REVISION 1  
TO  
51S-1 SERVICE BULLETIN NO 2

51S-1 COMMUNICATIONS RECEIVER (522-2245-030)  
51S-1A COMMUNICATIONS RECEIVER (522-2546-030)  
51S-1AF COMMUNICATIONS RECEIVER (522-3156-001)  
51S-1B COMMUNICATIONS RECEIVER (522-3857-001)  
51S-1F COMMUNICATIONS RECEIVER (522-2498-001)

## SERVICE BULLETIN NO 2

SUBJECT: Replacement of transformers T14 and T15 with mechanical filter

51S-1 HF Receiver, Partial Schematic Diagram  
Figure 1

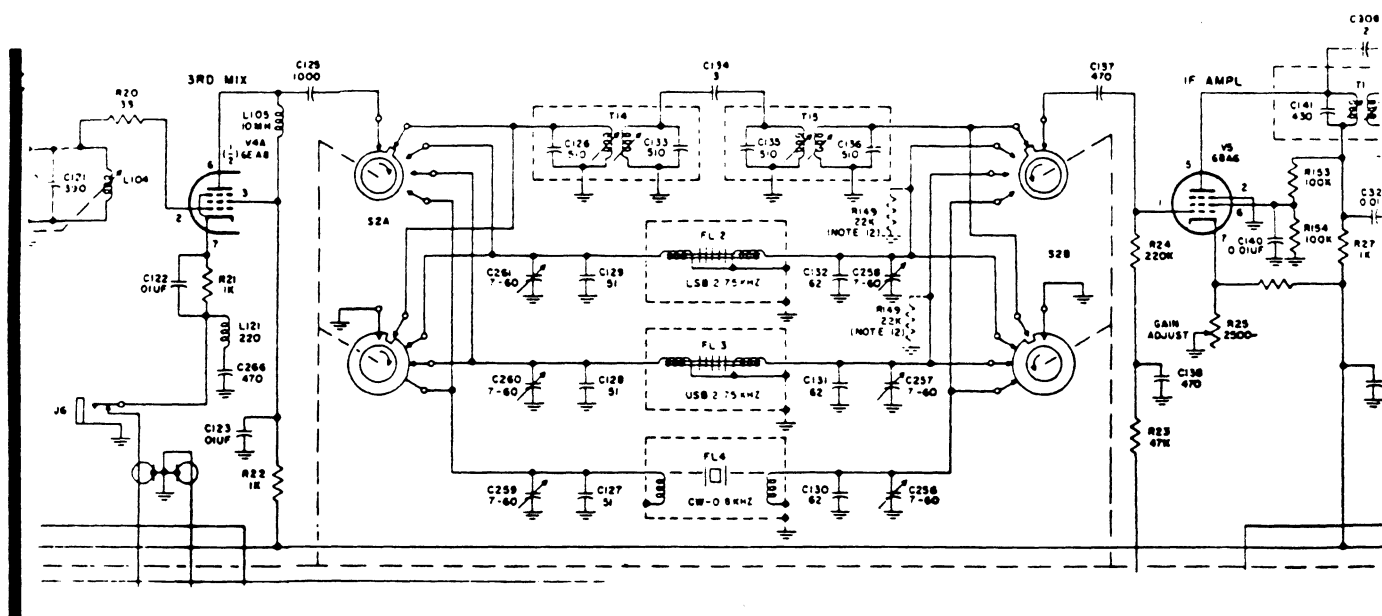
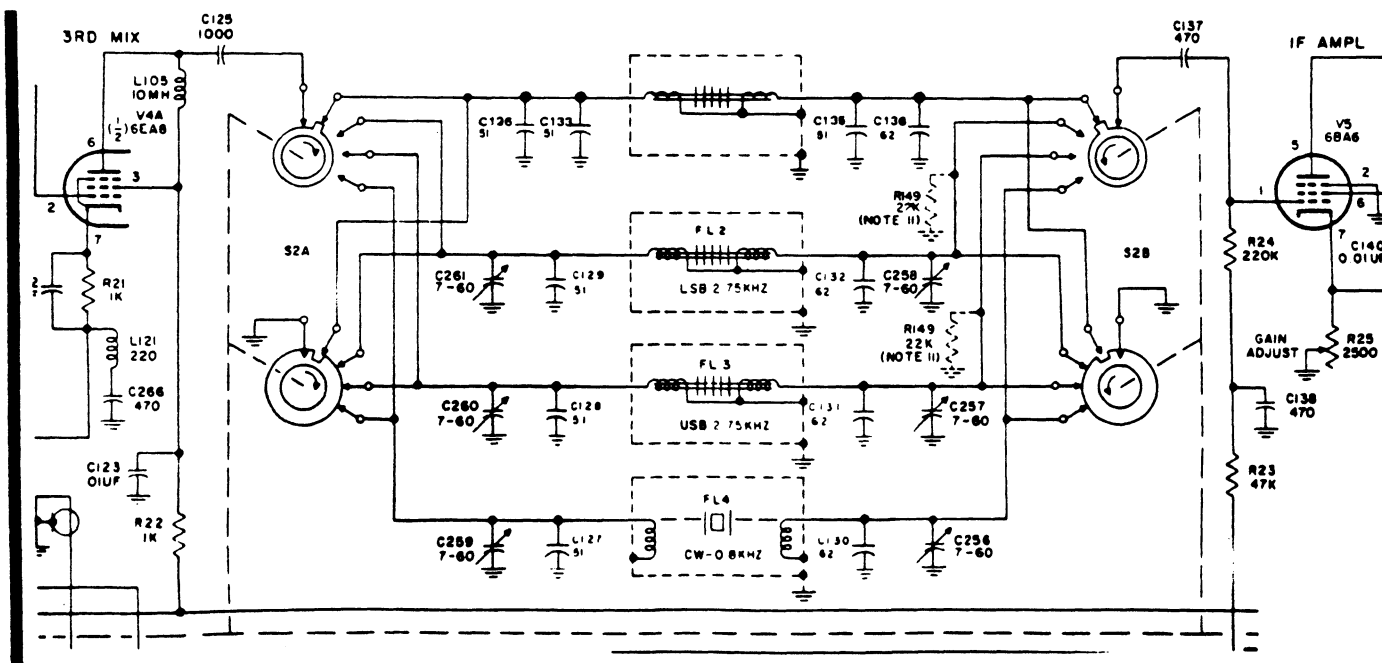
7. Page 3, modification information chart (Collins part number 280-3779-010), has been added to the list of parts.
8. Page 4, figure 1, partial schematic diagrams showing production configuration A before and after the modification has been added.

**NOTE:** The modification procedures depend upon the circuit configuration of the receiver. Configuration A in figure 1 shows fixed resonating capacitors (C127 through C132) across the input and output of each filter. Configuration B in figure 2 is the same circuit except C127 through C132 are removed and resonating capacitors C127 and C130 are switched to the input and output of the selected filter.

- b. Disconnect from S2B, the wire which was at T15. For configuration A, connect wire (421-2220-000) and parallel 51 pF (912-3858-000) and 62 pF (912-3864-000) capacitors to S2B as shown in figure 1.

- c. Disconnect from S2A, the wire which was at T14. For configuration A, connect wire (421-2220-000) and parallel 51 pF (912-3858-000) capacitors to S2A as shown in figure 1.

51S-1 HF Receiver, Partial Schematic Diagram

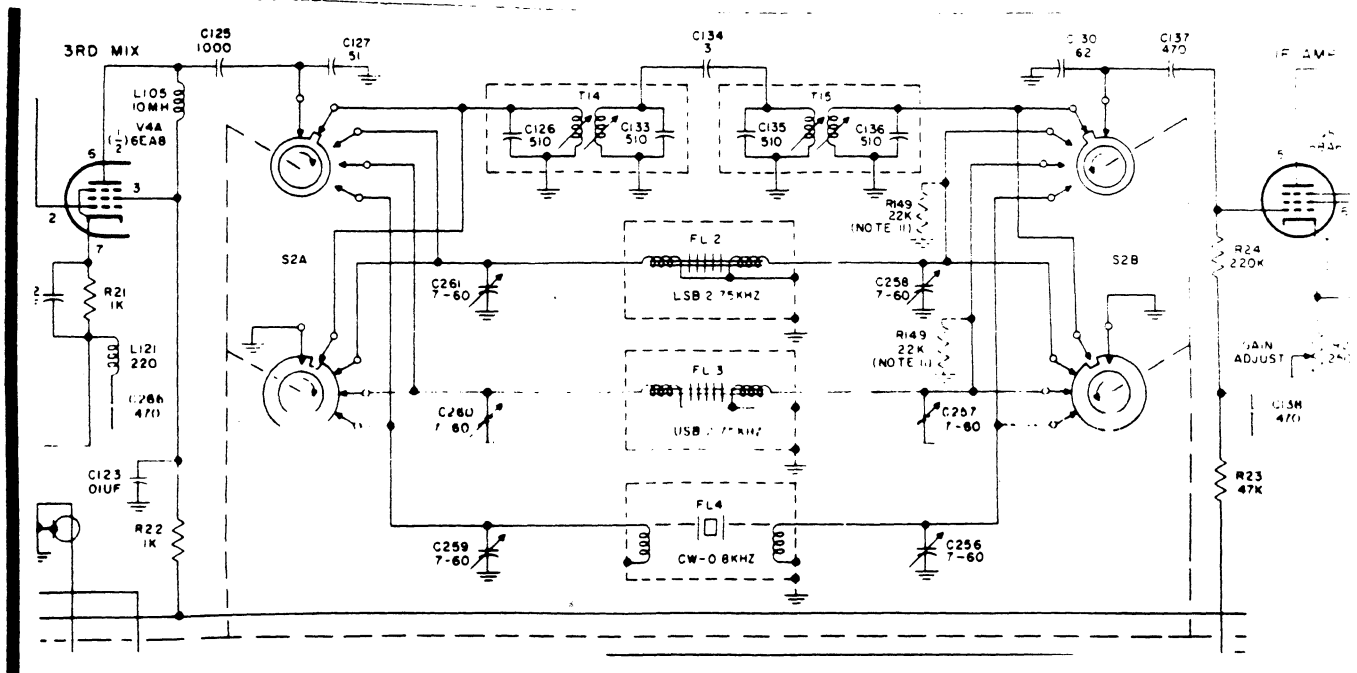
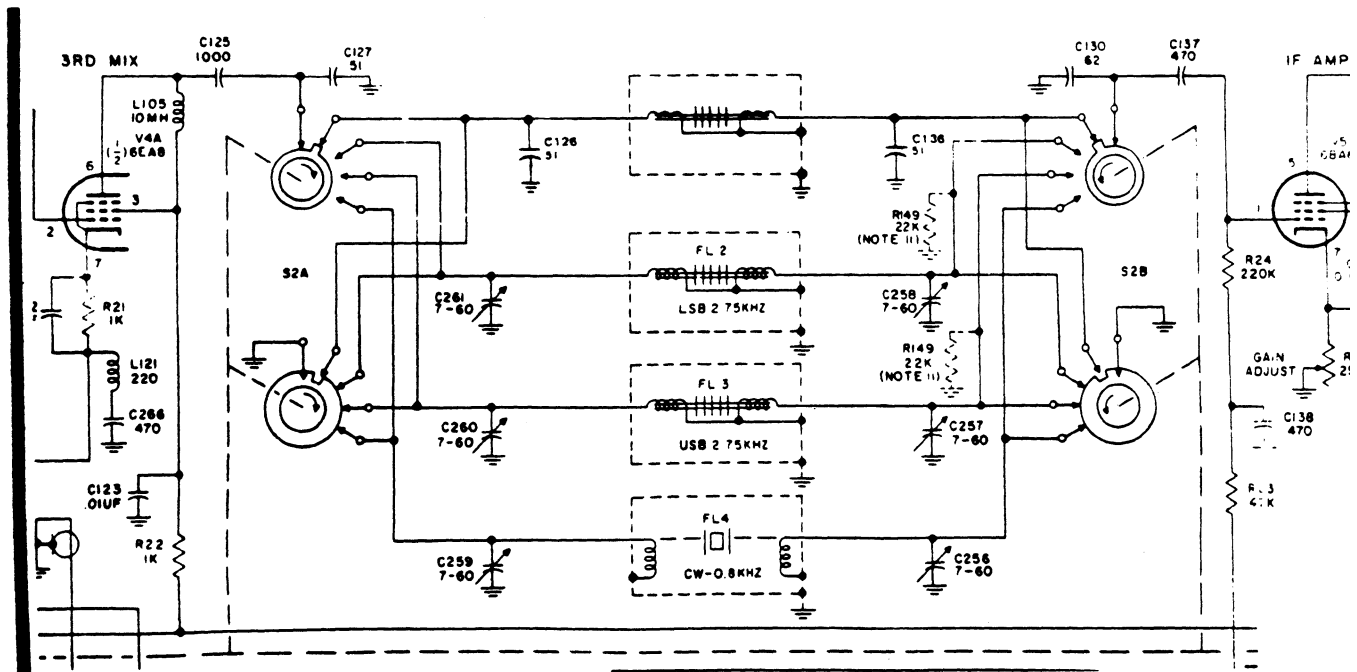
9. Page 5, figure 2, partial schematic diagrams showing production configuration B before and after the modification has been added.

For configuration B, connect wire (421-2220-000) and 51 pF (912-3858-000) capacitor to S2B as shown in figure 2.

For configuration B, connect wire (421-2220-000) and 51 pF (912-3858-000) capacitors to S2A as shown in figure 2.

51S-1 HF Receiver, Modification Components Locations  
Figure 3

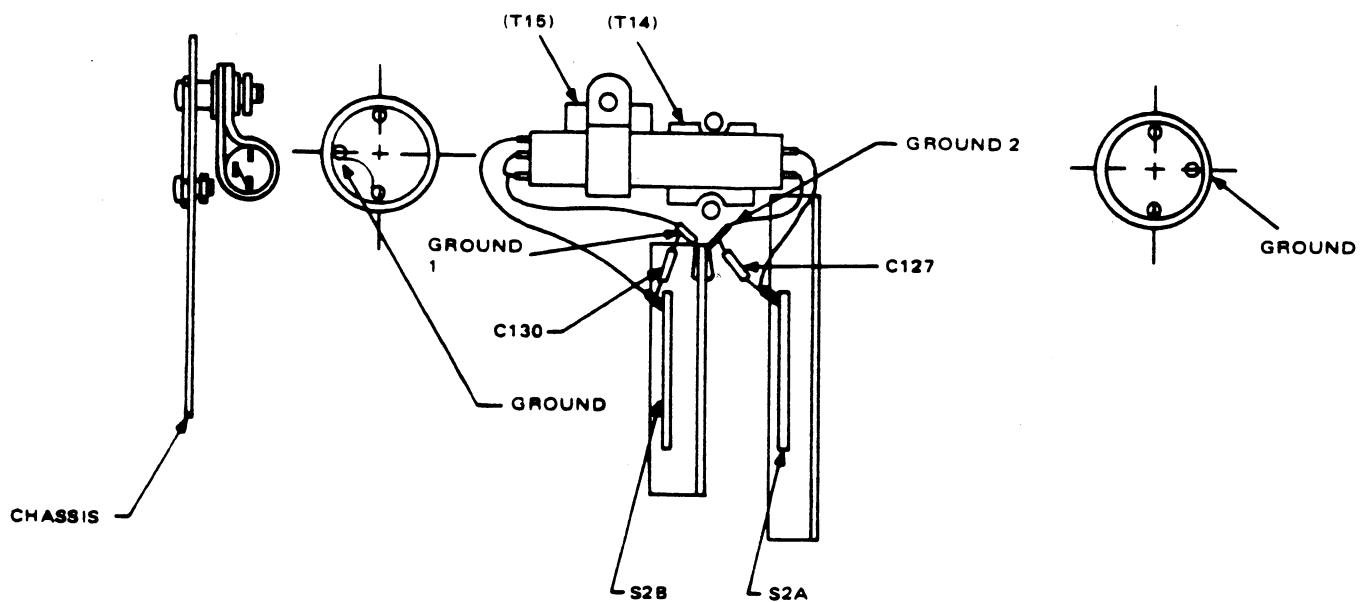
- d. Remove the bus wire from GRD1 that was connected to T14 and T15. Connect wire (422-2220-000) and loose end of capacitor in step b. to GRD 1. Insulate wire with sleeve (152-1558-000). Refer to figure 3.
- e. Connect bus wire (422-2220-000) and loose end of capacitor in step c. to GRD 2 (figure 3).
- f. Install plate covers (549-2836-002) on top of chassis; leave the screw hole to which the nylon filter clamp will be installed (step i.).
- g. Install wires from S2A and GRD 2 to mechanical filter (526-9378-000). Refer to figure 3.
- h. Install wires from S2B and GRD 2 to mechanical filter.
- i. Place nylon clamp over the mechanical filter and secure clamp to chassis hole (step f.).
